SAFETY RECALL BULLETIN

NHTSA RECALL 22V797

AUTOCAR, LLC SAFETY RECALL ACX-2206

Autocar, LLC has determined that a defect which relates to motor vehicle safety exists in certain Xpeditor (ACX) chassis. The steering column shaft pinch bolts may not be properly secured.

Figure 1, Steering Column Shaft

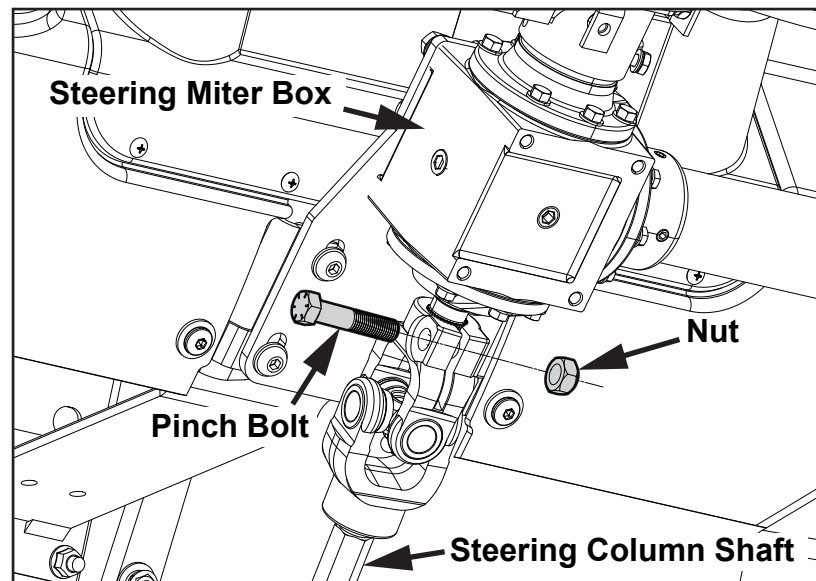
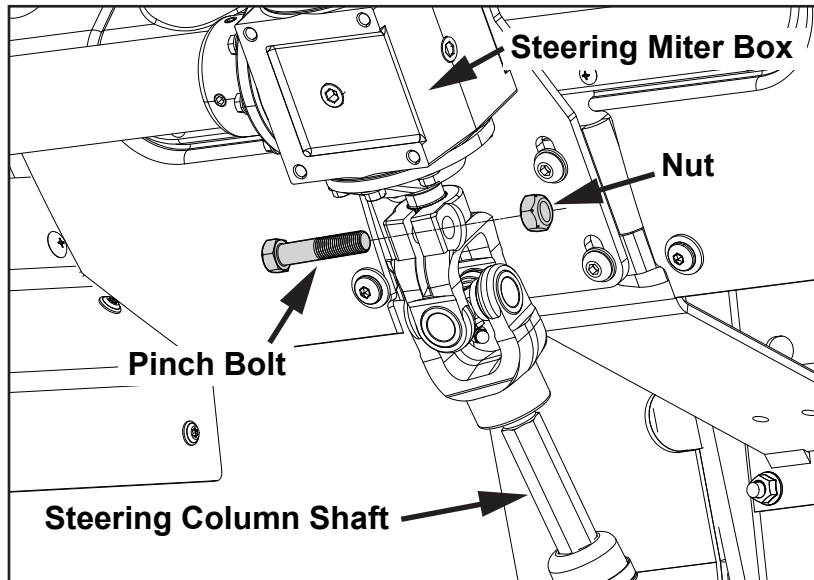
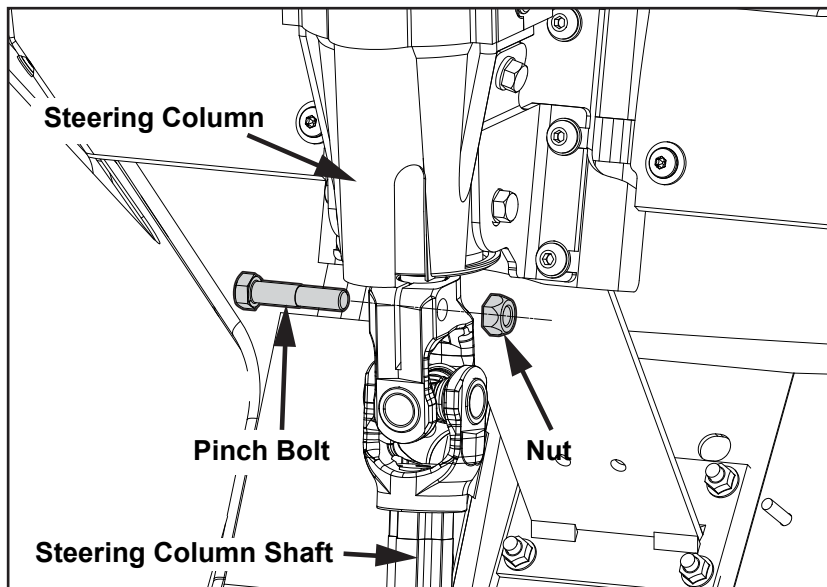
3. Remove and discard the steering column pinch bolt and nut at the base of the steering column or miter box (see *Figures 1, 2 and 3*).
4. Verify the steering column shaft is fully installed onto the steering column. At the base of the steering column or miter box, install (1) S38100009-001 bolt and nut, verify the bolt passes through the groove of the steering column and tighten to 75 Lbs.-ft. of torque (see *Figure 4*).

Figure 5

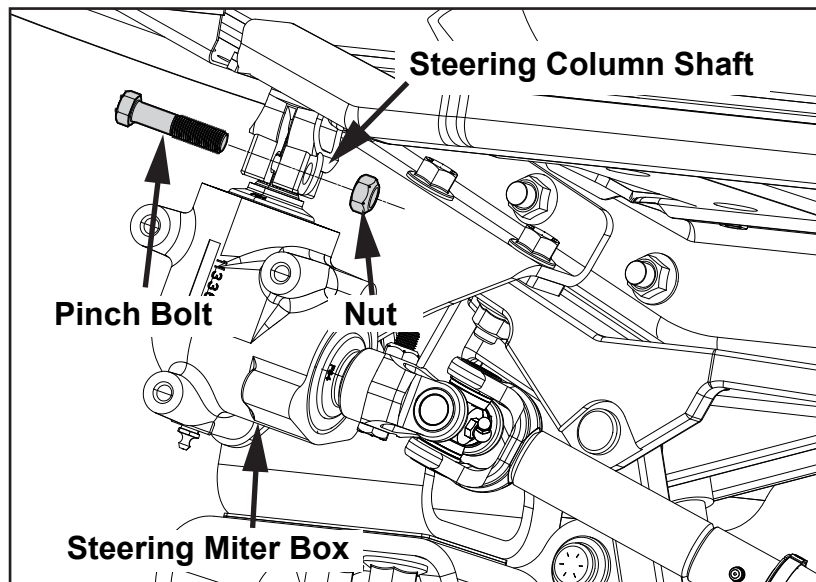
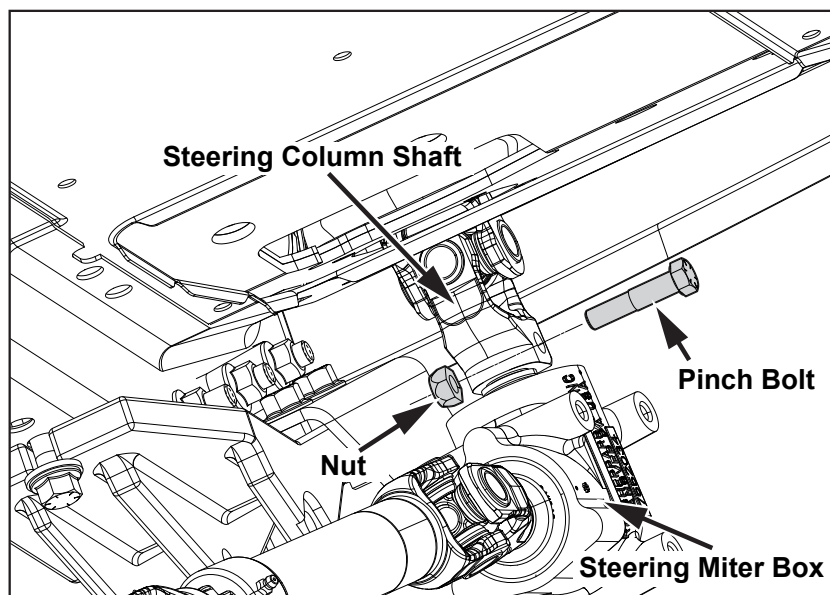
8. Remove and discard the steering column shaft pinch bolt and nut at the miter box.
9. Verify the steering column shaft is properly installed. Install (1) S38100009-001 Bolt and nut at the steering column miter box, verify the bolt passed through the groove in the miter box shaft and tighten to 75 Lbs.-ft. of torque (see *Figure 4*).
10. Lower the cab.
11. Turn on the battery disconnect or reconnect the battery cables beginning with the positive cables, followed by the negative cables.
12. Repairs are complete.
